PCI-SIG DRAFT ENGINEERING CHANGE NOTICE

TITLE:	Trusted Configuration Space for PCI Express
DATE:	March 23, 2005
AFFECTED DOCUMENT:	PCI Express Base Specification, Rev. 1.1
SPONSOR:	Microsoft Corporation, Intel Corporation

Figure 2-16: Request Header Format for Configuration and Trusted Configuration Transactions

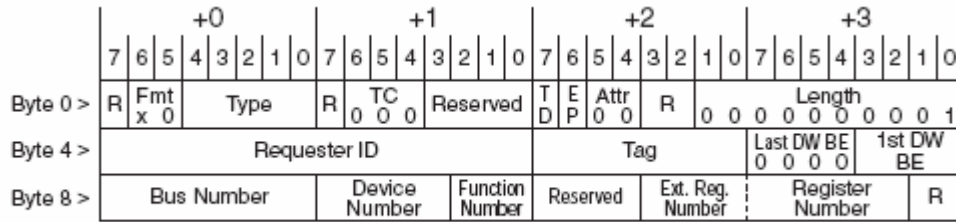
For Configuration and Trusted Configuration Requests, the following rules apply:

- ❑ Configuration and Trusted Configuration Requests route by ID, and use a 3 DW header
- ❑ In addition to the header fields included in all Memory, I/O, ~~and~~ Configuration and Trusted Configuration Requests and the ID routing fields, Configuration and Trusted Configuration Requests contain the following additional fields (see Figure 2-16)
 - Register Number[5:0]
 - Extended Register Number[3:0]

❑ Configuration and Trusted Configuration Requests have the following restrictions:

- TC[2:0] must be 000b
- Attr[1:0] must be 00b
- Length[9:0] must be 00 0000 0001b
- Last DW BE[3:0] must be 0000b

Figure 7-11: PCI Express Capabilities Register

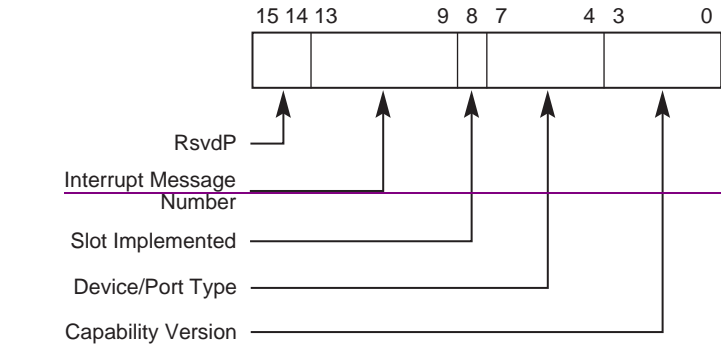
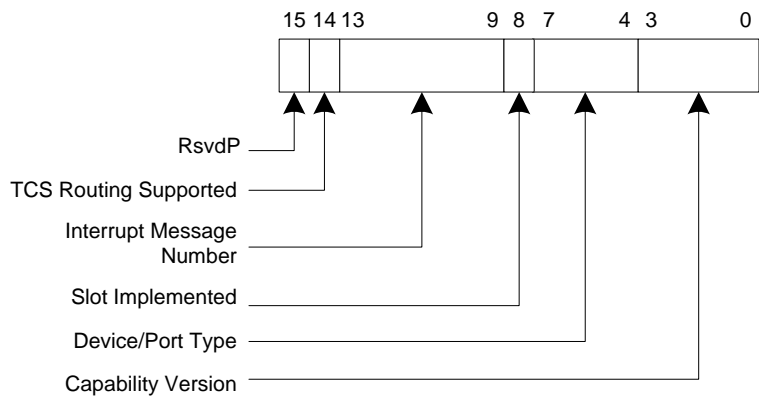
- ◆ 520 Figure 7-11 details allocation of register fields in the PCI Express Capabilities register; Table 7-10 provides the respective bit definitions.

Figure 7-87: Configuration Access Correlation Capability

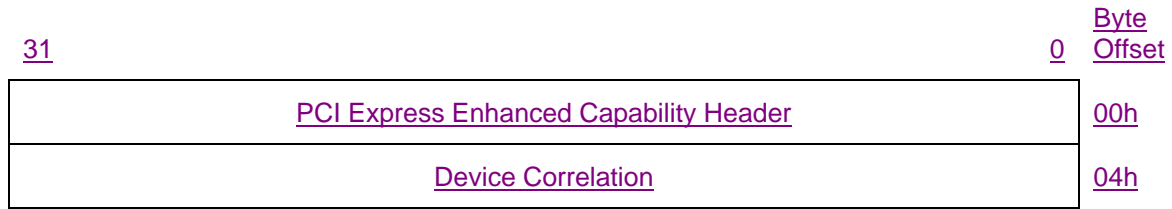
◆ 535 The PCI Express Configuration Access Correlation (CAC) capability is an optional extended capability that must be implemented by any PCI Express device that provides a Trusted Configuration Space. The CAC is used by software running within the TSE to identify Trusted Devices. Contained within the CAC is a read-only 32-bit value that is used by software running within the TSE to validate that Standard Configuration Space accesses performed via ECAM are targeting the same device as Trusted Configuration Space accesses performed via the corresponding TCAM. Figure 7-87 details allocation of register fields in the PCI Express Capability structure.

◆ 540 PCI Express devices that implement this capability must also implement the corresponding CAC Trusted Capability in Trusted Configuration Space (see Section 7.21.2). Both capabilities must access the same register for the Device Correlation—it is by this means that correlation is verified by software running in the TSE.

Figure 7-90: Trusted Configuration Space Header

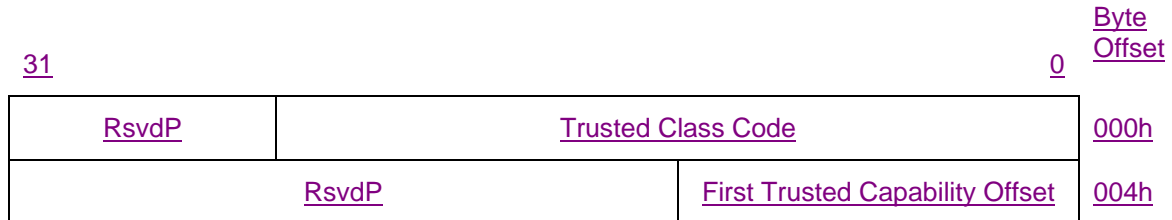
◆ 565 Figure 7-90 details allocation for register fields of the Trusted Configuration Space header for PCI Express Trusted Devices; Table 7-77 provides the respective bit definitions. The Trusted Configuration Space header identifies the device class to software running in the Trusted Software Environment, and it points to the first Trusted Capability structure.

Figure 7-91: Configuration Access Correlation Trusted Capability

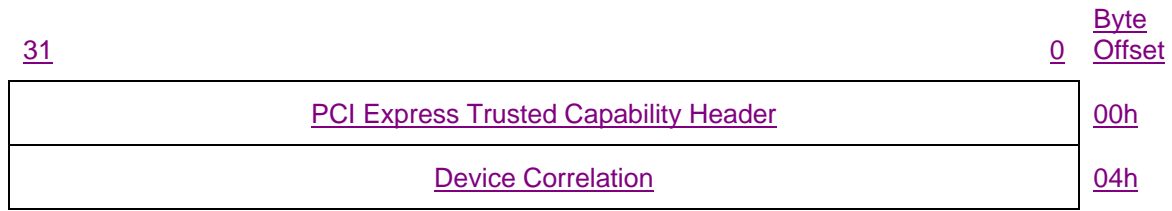
Figure 7-91 shows the PCI Express Configuration Access Correlation Trusted Capability structure.

Figure 7-94: PCI Express VSTC Structure

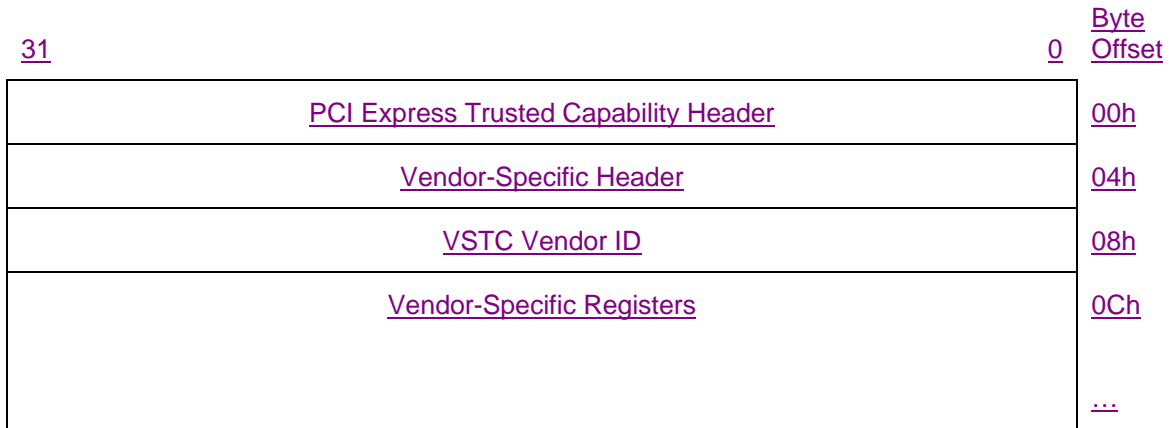
- ◆ 620 The VSTC in Trusted Configuration Space serves a similar purpose to that of the Vendor-Specific Extended Capability (VSEC) in Standard Configuration Space, as described in Section 7.18. The VSTC differs from the VSEC in that PCI Express functions are permitted to supply (public) VSTCs defined by vendors other than the device's vendor (as identified by the Vendor ID register located at byte offset 00h in PCI-compatible Configuration Space).

- ◆ 625 Figure 7-94 details allocation of register fields in the VSTC structure. The structure of the PCI Express Trusted Capability Header, the Vendor-Specific Header, and the VSTC Vendor ID is architected by this specification. The structure and definition of the Vendor-Specific Registers area is determined by the vendor indicated in the VSTC Vendor ID register located at offset 08h within the VSTC structure.

◆ 695 **Figure X-1: Gating TCS Access Via TPM**

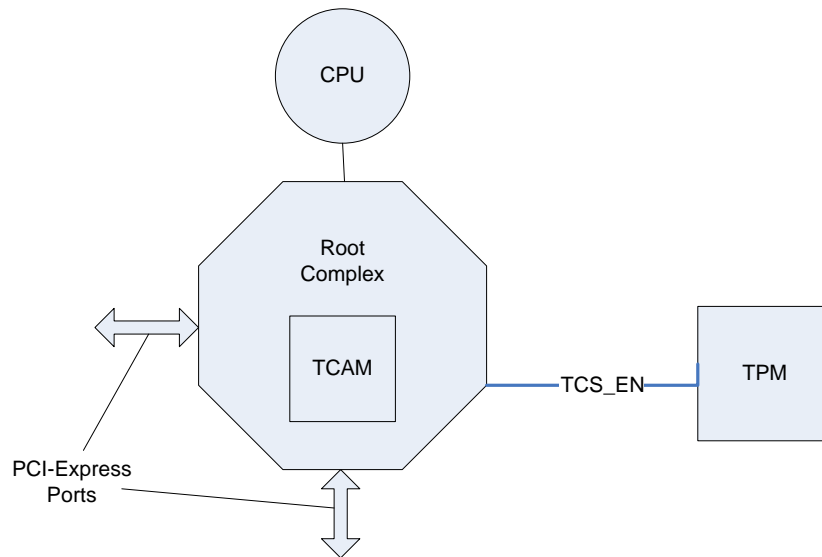
The system board for our example implementation would connect TPM GPIO pin 0 to the TCS_EN# pin of the root complex as illustrated in Figure X-1 below.
